Access Compliance Report

Public Rights-of-Way

(Curb Ramps)

Intersection ID: 14598	Main Street: N_CHASE_ST	Cross Street: RANDOLPH_RD	Location: NE
ADA ID: 8C5AAA56ED59	Ramp Type: Perp	Initial Pass/Fail: Pass	Overall Compliance: No
Severity Score: 22.5			
Codes/Mitigation Info/Possible Solution		Field Measurements/Component Compliance

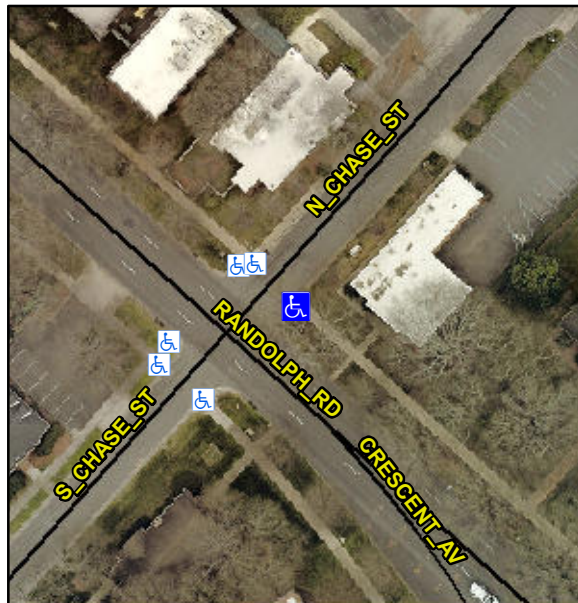
Compliance	Description	Data	Compliance	Description	Data
N/A	Ramp Length (in)	67.0	Yes	Ramp Slope (%)	6.0
Yes	Ramp Width (in)	48.0	Yes	Ramp XSlope (%)	1.5
N/A	Flare Type LT	Sloped	N/A	Flare Type RT	N/A
N/A	Flare Slope LT (%)	8.9	No	Flare Slope RT (%)	10.2
N/A	Flare Traversable LT?	Yes	N/A	Flare Traversable RT?	Yes
Yes	Landing Length (in)	57.0	Yes	DWS Provided?	Yes
Yes	Landing Width (in)	74.0	Yes	DWS Contrast?	Yes
No	Landing Slope (%)	5.3	Yes	DWS Length (in)	25.0
Yes	Landing X Slope (%)	0.2	Yes	DWS Full Width?	Yes
N/A	Landing Curb? (Y/N)	No	Yes	DWS Offset (in)	2.0
N/A	Shared Landing?	No			
Yes	Gutter Ponding?	No	No	Gutter Slope (%)	8.9
No	Gutter Lip Ht (in)	2.0	Yes	Gutter X Slope (%)	1.2
N/A	Painted X Walk1?	No	N/A	Painted X Walk2?	N/A
	X Walk 1 Direction	To NW		X Walk 2 Direction	N/A
N/A	X Walk 1 Width (in)	N/A	N/A	X Walk 2 Width (in)	N/A
	X Walk 1 Slope (%)	9.9		X Walk 2 Slope (%)	N/A
	X Walk 1 X Slope (%)	0.9		X Walk 2 X Slope (%)	N/A

N/A	Ramp inside XWalk1?	N/A	N/A	Ramp inside XWalk2?	N/A
	Road Slope (%)	N/A	N/A	Clear Space?	Yes
	Road X Slope (%)	N/A	N/A	Clear Space to XWalk (in)	N/A
Yes	Any Obstructions?	No	Yes	Storm Grate/Utility Hazard?	No
	Obstruction Type			Storm Grate/Utility Type	
		N/A			N/A
		Yes	Yes	Surface Condition? (G/P)	Good

**Remove & Replace Entire Ramp.
Remove & Replace Gutter.**

**R304.2.2-Perp, R304.3.2-Para,
R304.2.3, R302.7.2, R304.5.4**
